Submission to Draft Cork City Development Plan 2022-2028

On behalf of O'Callaghan Properties

October 2021
No. 21595

Figure 1 Map 06 in the Draft Cork City Development Plan

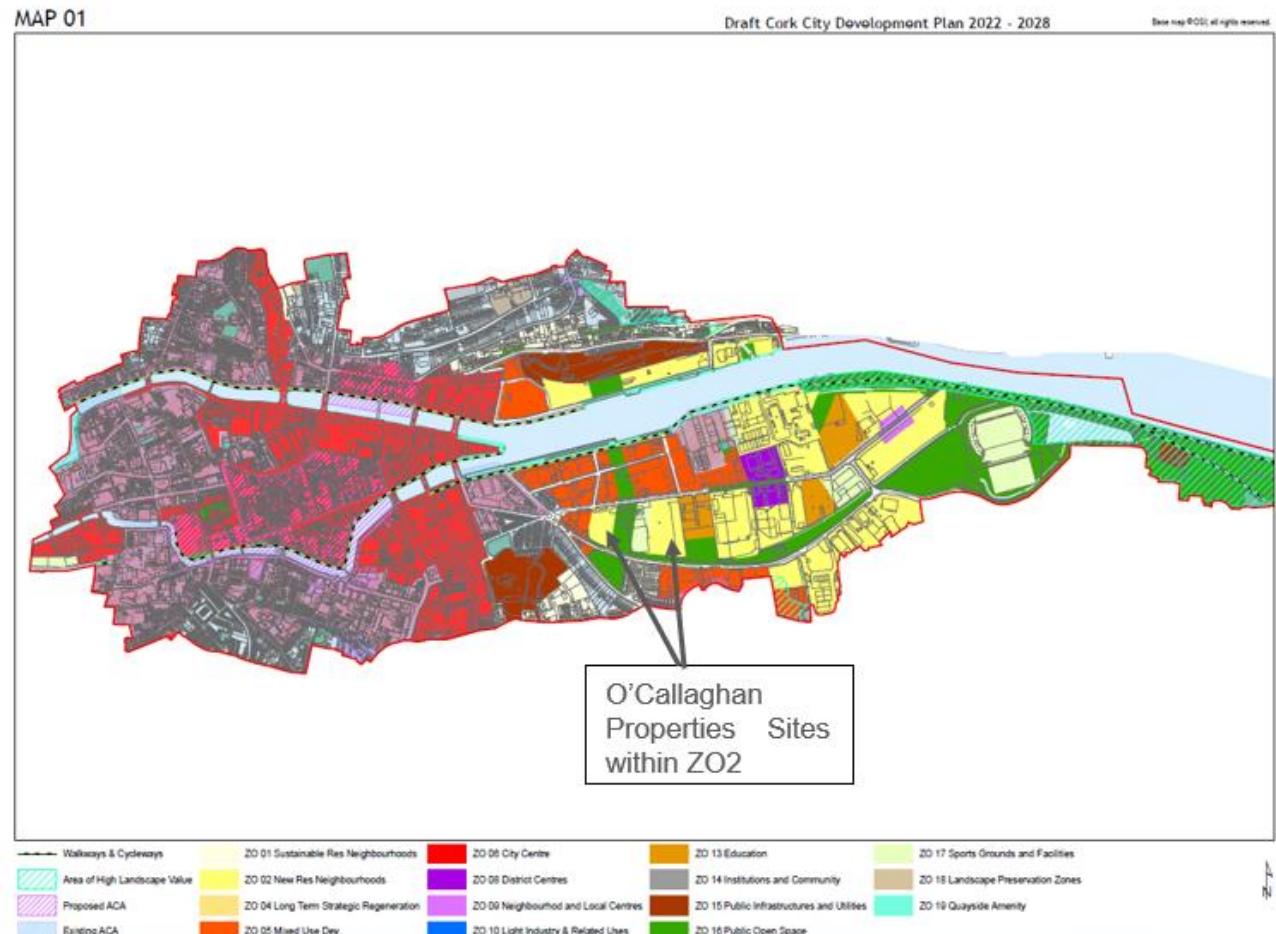
The proposed application of the New Residential Neighbourhood zoning to a large proportion of sites within the South Docklands as indicated in Figure 1 will result in mono/single use developments comprising predominantly residential land use arising. This would be a surprising and sub-optimal outcome for an area long designated by Cork City Council in its policy documents as an extension of the city centre. We believe that the proposed zoning approach for the South Docklands in the Draft Plan will not create conditions conducive to the required large-scale regeneration of this area. It has the potential to undermine the vision for the development of the docklands as set out in the National Planning Framework (NPF) and the Southern Regional Spatial and Economic Strategy (RSES), both of which set the strategic context for the Draft Plan.

For the above reasons, it is requested that our client's sites between Centre Park Road and Monahan Road that are indicated within the New Residential Neighbourhood Zoning should retain their extant a Mixed-Use land use zoning objective. Please refer to Figure 4 which outlines in red the sites requested to remain within a Mixed-Use land use zoning objective category.

Figure 5 OCP Lands overlain by Proposed Draft City Development Plan Zonings

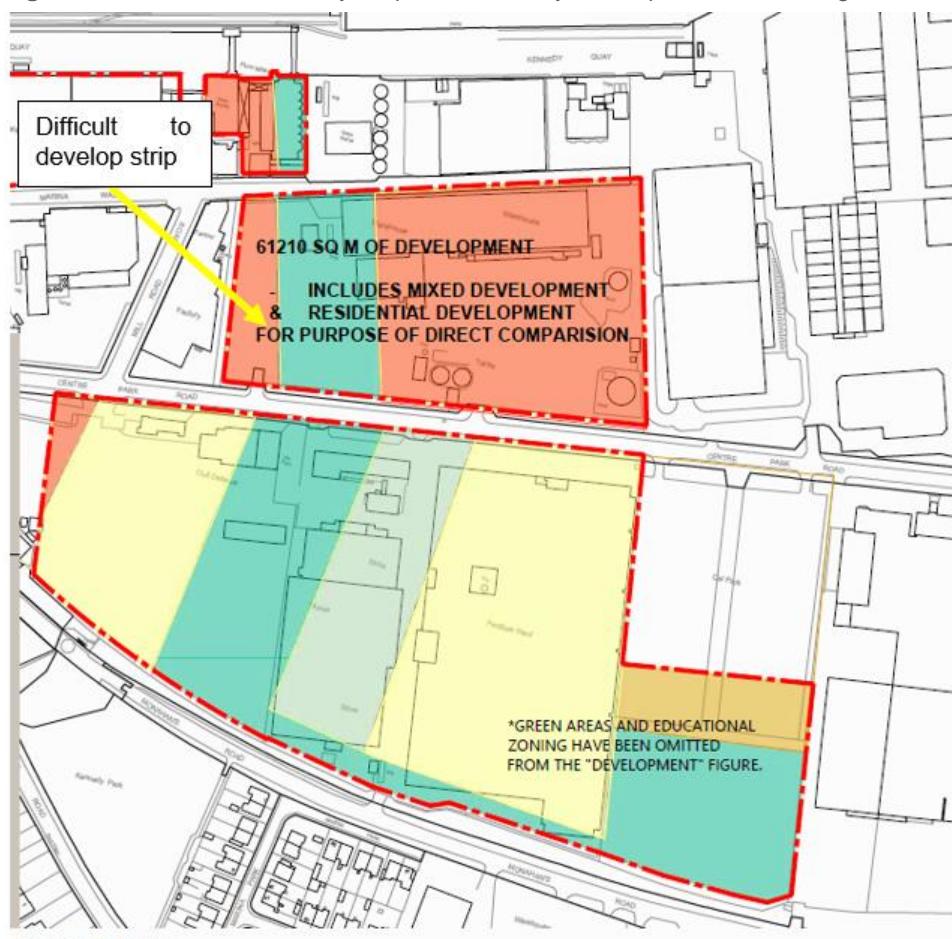
The comparison with the Draft Plan indicates that this would increase to 40.5% public open space and sports facilities on our clients' lands or a ratio of 2:3 green space: development lands. This is a substantial increase in public open space and amenity facilities especially when one considers the provision of public open space further west within South Docklands. The proposed substantial increase

The location and configuration of the proposed sports grounds and open spaces will further frustrate the development of the OCP landholding. For example, Figure 5 shows that the relocated Kennedy Spine which has been substantially increased in width results in a narrow strip of land in OCP ownership that will be very difficult to develop. The increased width of Kennedy Spine is not necessary. It is requested that it is maintained in width as per the current Cork City Development Plan. We also respectfully request that the City Council consider the relocation of the proposed Kennedy Spine which will comprise a linear amenity park combining urban zones with green open space further west within the South Docks as indicated within Figure 10.8 of the Draft Plan (and included at Figure 6 below).

On the basis of the arguments made above, we request that Cork City Council remove the part of our client's site from within the Sports Grounds and Facilities land use zoning category as it is we believe surplus to requirements and instead include this within a Mixed-Use land use zoning category which would be considered more suitable land use to optimise development at this location within the docklands. It is further requested that the width of the proposed Kennedy Spine is maintained as per the current Development Plan and that it is relocated further west as previously envisaged.

Figures 6a and 6b Proposed Sports Grounds and Facilities in Draft Cork City Development Plan 2022-2028

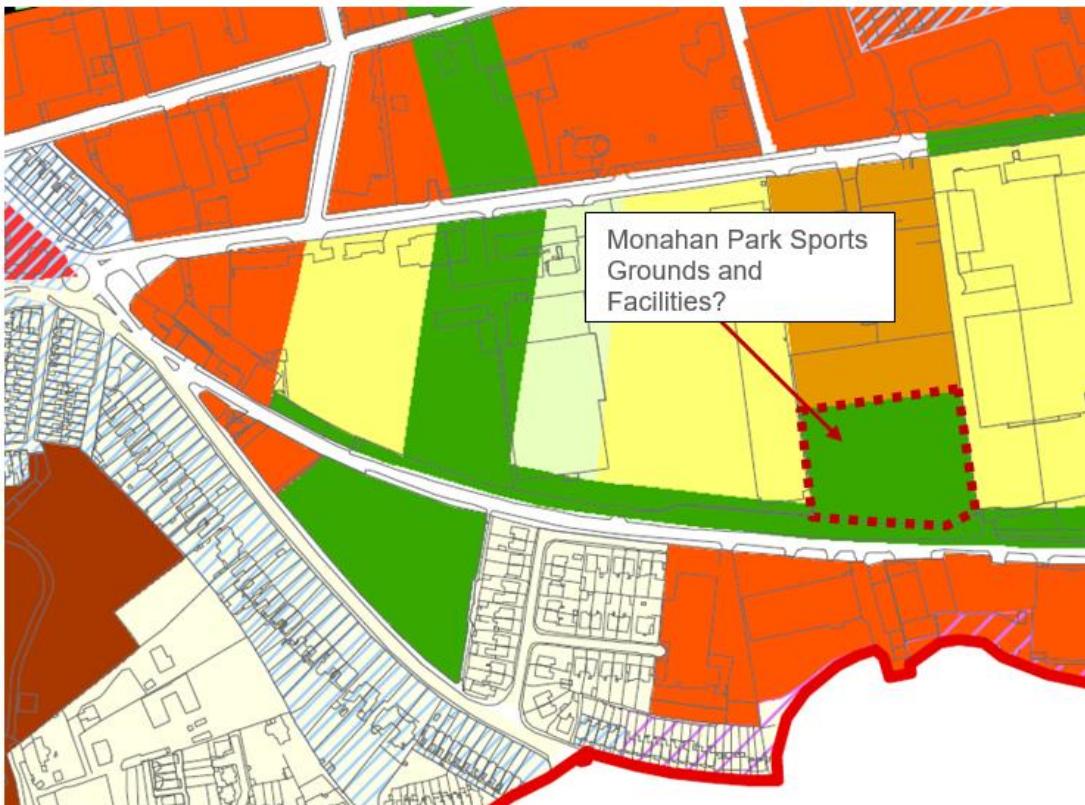
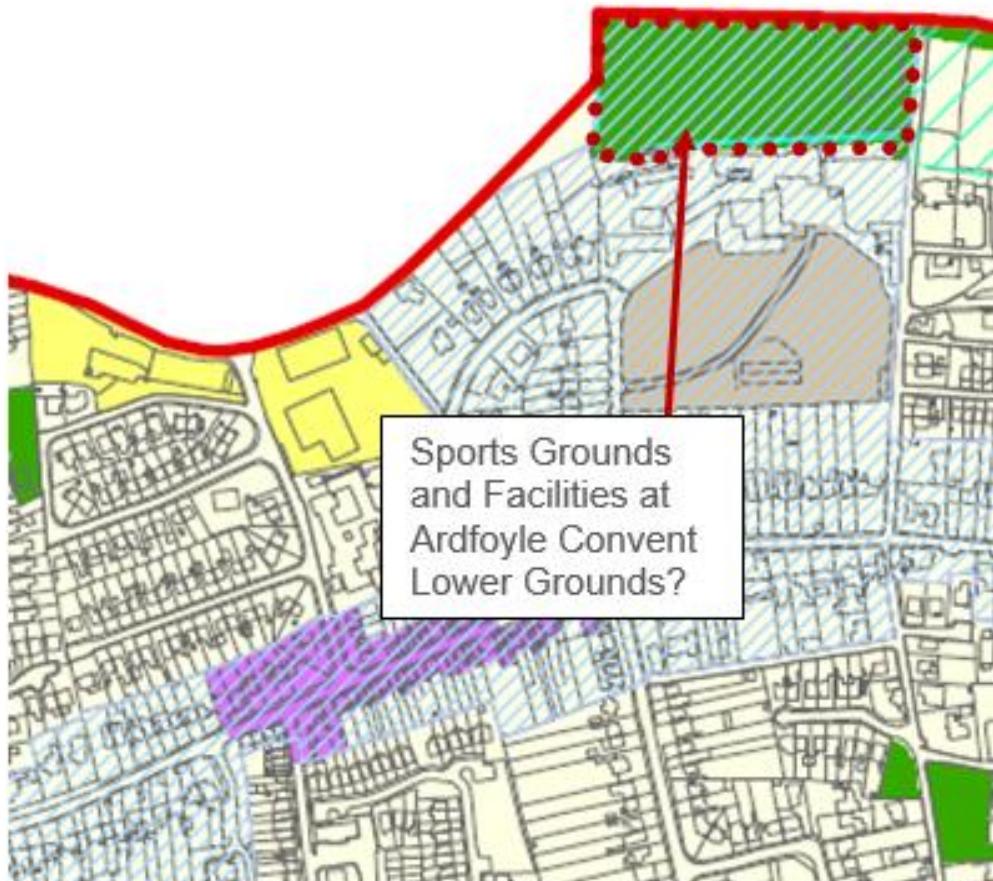
It is noted that the proposed Sports Grounds and Facilities for Monahan Park and Ardfoyle Convent Lower Grounds are indicated within the ZO16 Public Open Space in the Draft Plan zoning maps when they should be included within the Sports Grounds and Facilities zoning.

We do not believe that it is appropriate to include the land directly to the east of the proposed Kennedy Spine between Centre Park Road and Monahan Road within a Sports Grounds and Facilities Zoning from a land use planning perspective due to the close proximity of a proposed pitch as part of Monahan Park adjoining the school site to the southwest.

Figure 7 Extract from Draft Cork City Development Plan 2022-2028 (Figure 10.8)

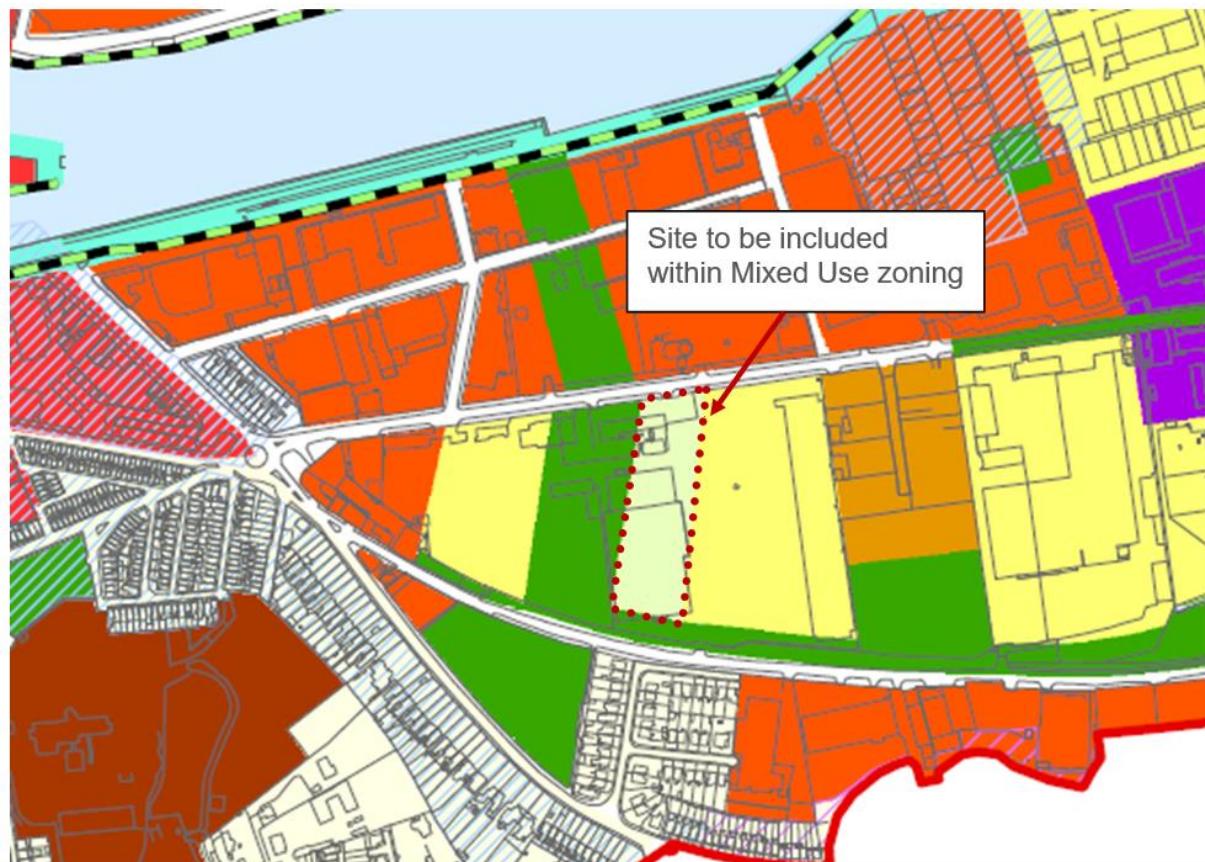
The inclusion of land for Sports Grounds and Facilities directly adjacent to Kennedy Spine will create a much more expansive and wider green corridor at this location between Centre Park Road and Monahan Road. We believe this will have a negative impact on the vision for the spine as a linear urban

park that provides a place to rest and play and that draws people through dense docklands development towards the quayside. It will also create an unpleasant micro climate for those using it.

Figure 10 Cork City Public Transport Infrastructure Indicative Timeline

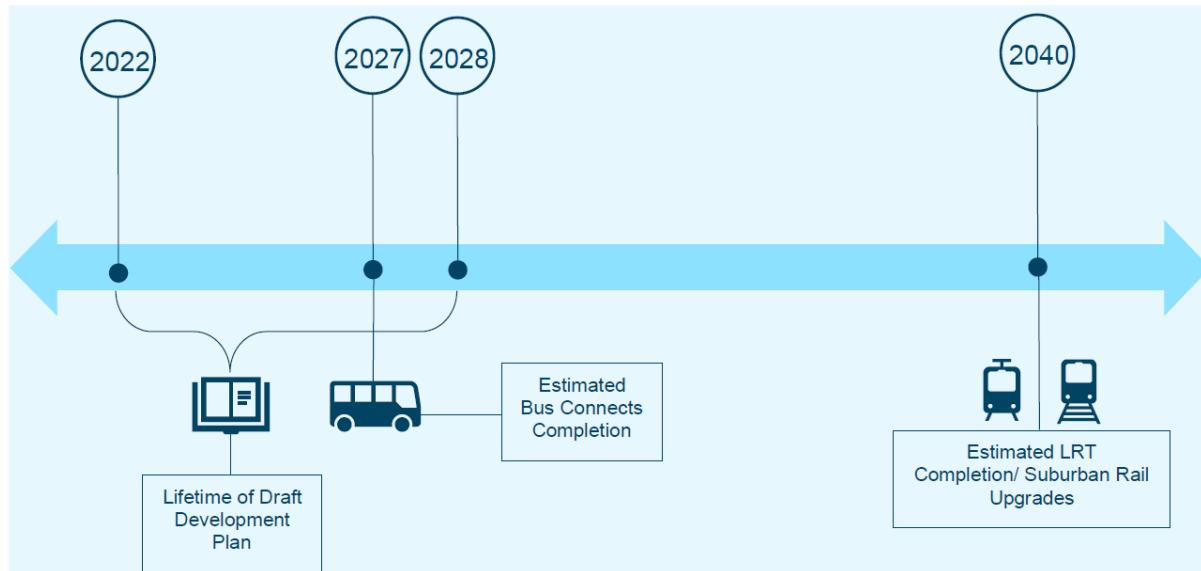
The Atkins submission sets out the proposed timelines for CMAT's public transport infrastructure against the timeline of the emerging Cork City Development Plan. It is clear that the majority of the proposed infrastructure will not be delivered within the lifetime of this Development Plan.

We ask that Cork City Council adopts a flexible approach to car parking in the first phases of development in the South Docklands in the absence of the public transport that is proposed to serve this extension of the City Centre. Car parking for these initial phases of development should be aligned with the current standards in the current plan until the public transport provision is in place and as described above a phased approach to car parking corresponding with the delivery of public transport improvements over the short, medium and longer term
